SANTA CRUZ COUNTY GROUP Of The Ventana Chapter P.O. Box 604, Santa Cruz, CA 95061 <u>https://www.sierraclub.org/ventana/santa-cruz</u> email: <u>sierraclubsantacruz@gmail.com</u>

Re: Laurel St. Bridge/Pure Water Soquel Conveyance Project Habitat Impact

May 8, 2024

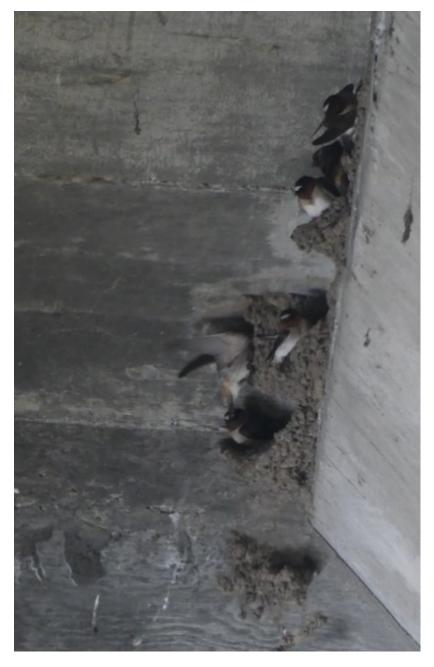
Recent observations confirm that cliff swallows are now nesting under the Laurel Street Bridge in the area which appears to be the next area of construction, as part of the ongoing installation of the pipe covers. These nests appear to be within 10 feet of the next phase of installation of the covers, as seen below:

The installed covers are seen at the upper right of the first photo, and if the cover installation proceeds it will be within feet of cliff swallow nests. Photos of the nests are seen here:

The mitigation measure clearly states that if nesting birds are identified, that a suitable protective buffer shall be defined, and that no activities shall occur within this buffered area. The required bird survey either took place too early to capture this nesting activity, or did not take place at all. Regardless, cliff swallows are nesting at the site, and one purpose of this letter is to make clear that you are on notice of this fact.

The Sierra Club asserts that the EIR for this project requires that no further work be done near the above-identified area of the Laurel Street Bridge, and further that a biologist is now needed to determine the buffer area. The Sierra Club believes, in light of observations of swallow behavior around construction activities to date, that this buffer will preclude further work in the identified area until after the end of the nesting season.
